# SA Government – 2020 Inverter Standards

# SA Proposed Inverter Standards – Tesla response to consultation papers

# Summary – Tesla response

**Figure 1: SAVPP FCAS response to Kogan Creek contingency event**

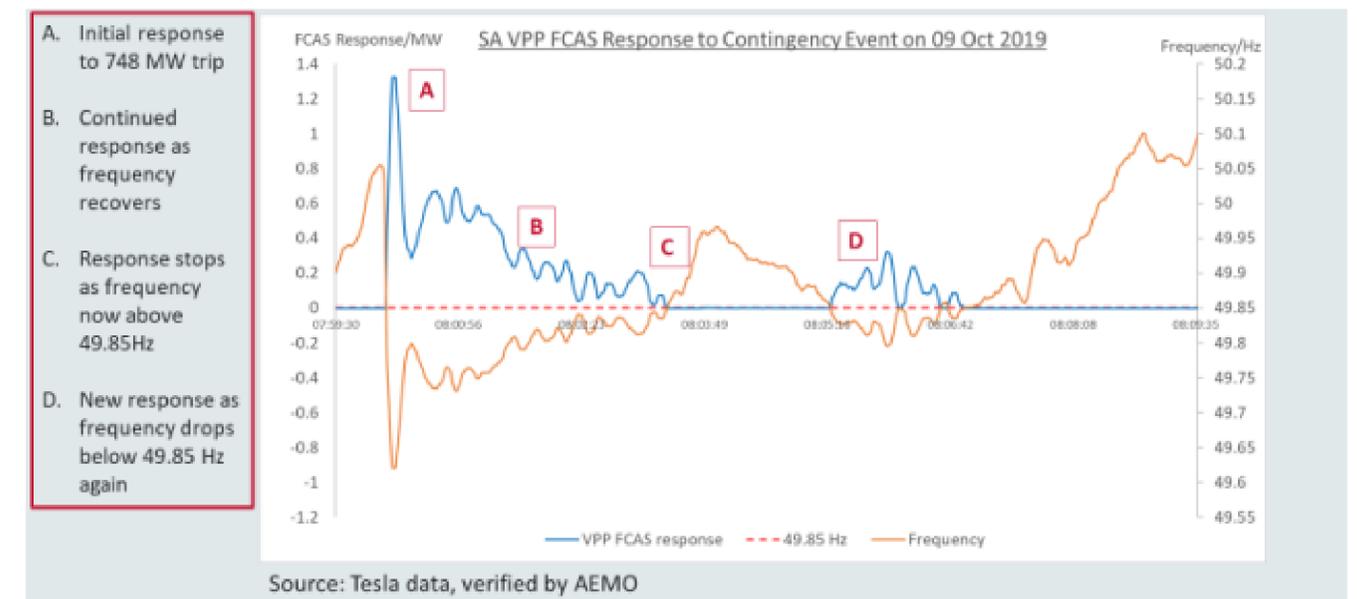
- It also noted the high-quality frequency control ancillary services (FCAS) that can be provided by VPPs – see Figure 1. Higher penetrations of VPPs providing these high-quality services will benefit the state.
